Product Change Notification / BLAS-26KOZC951

CCB 6542 Final Notice: Qualification of HANA as an additional assembly site for MCP1793T-3302H/DC, MCP1793T-3302H/DCVAO, MCP1793T-4102H/DC, MCP1793T-4102H/DCVAO, MCP1793T-5002H/DC and MCP1793T-5002H/DCVAO catalog part numbers (CPN) available in 5L SOT-223 package.

Pre and Post Change Summary

LEAD FRAME COMPARISON

LPI

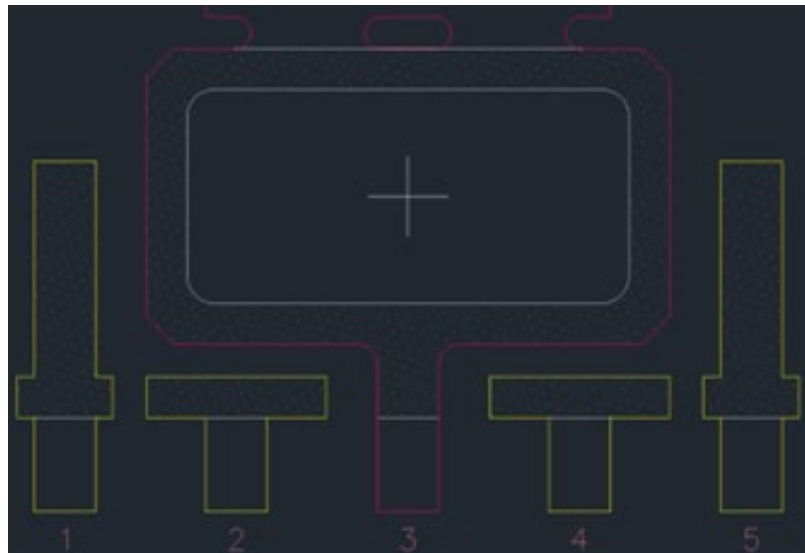
Description of Change:Qualification of HANA as an additional assembly site for MCP1793T-3302H/DC, MCP1793T-3302H/DCVAO, MCP1793T-4102H/DC, MCP1793T-4102H/DCVAO, MCP1793T-5002H/DC and MCP1793T-5002H/DCVAO catalog part numbers (CPN) available in 5L SOT-223 package.
